Service Bulletin

Category B	Applicable Model/s 1988-'90 626/MX-6	Subject HYDRAULIC LASH ADJUSTER (HLA) NOISE	Bulletin No. 004/90 Issued 6/8/90 Revised
---------------	--	--	---

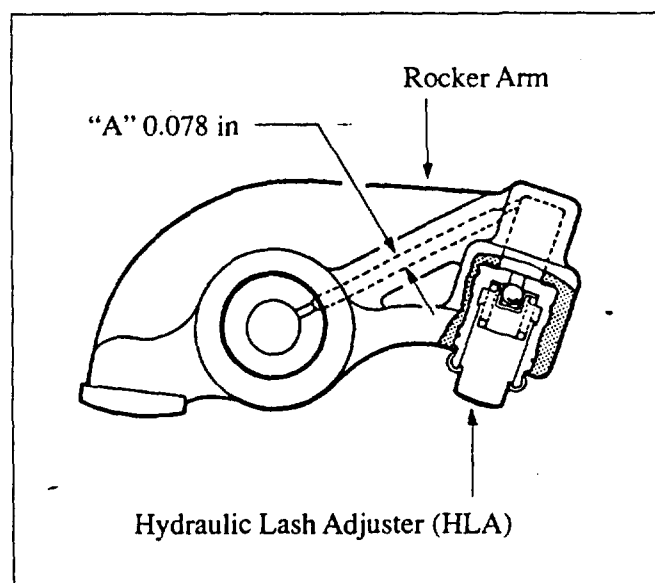
As illustrated, the diameter of the oil passage "A" on the modified rocker arm has been enlarged (0.031 in to 0.078 in). With this modification, oil volume to the HLA increases and the period of HLA noise is reduced.
